Project	IEEE 802.16 Broadband Wireless Access Working Group < <u>http://ieee802.org/16</u> >
Title	Clarification on [4, 8, 16] Midamble Repetition Interval
Date Submitted	2005-05-02
Source(s)	Lei Wang, Cygnus Communications, Inc.Voice: +1-403-207-6479 Fax: +1-403-273-5100Ron Murias, Dorin Viorel, Jagan Seshadri, Shane Rogers, Wi-LAN Inc.Voice: +1-403-207-6479 Fax: +1-403-273-5100E-mail: dviorel@wi-lan.com
Re:	Response to the call for comments IEEE 802.16-2004/Cor1-D2 Corrigendum to IEEE 802.16-2004
Abstract	Midamble repetition intervals [4, 8] are not suitable for a fixed wireless access propagation environment, due to the lack of Doppler induced effects.
Purpose	Change the midamble repetition interval to the previous values [8, 16, 32].
Notice	This document has been prepared to assist IEEE 802.16. It is offered as a basis for discussion and is not binding of the contributing individual(s) or organization(s). The material in this document is subject to change in form and content after further study. The contributor(s) reserve(s) the right to add, amend or withdraw material contained herein.

Clarification on 802.16-2004 OFDM SS Tx Rf and Sampling clock frequency tolerance

Figure 6-1. Number of Doppler induced fades per second for different speed rates.

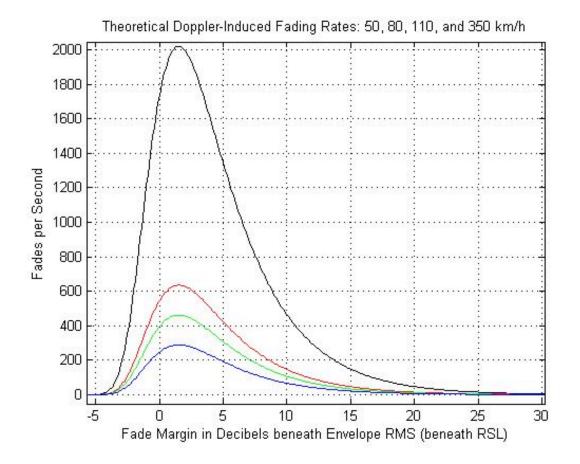
Based on the Equation 2-1, the related Doppler fades per second relative to the mobile user's speed is presented in Appendix 1.

Accordingly, the average number of Doppler induced fades per second for a user moving with 350 km/h (high speed train) is around 2000, which corresponds to an average period of flat fading equating with 0.5 ms.

For a user moving at 110 km/h, the related average number of Doppler induced fades per second is around 620 fades/second with a related average period of flat fading equal to 1.61 ms. We consider now an OFDM256 signal used in a BW=3.5 MHz.
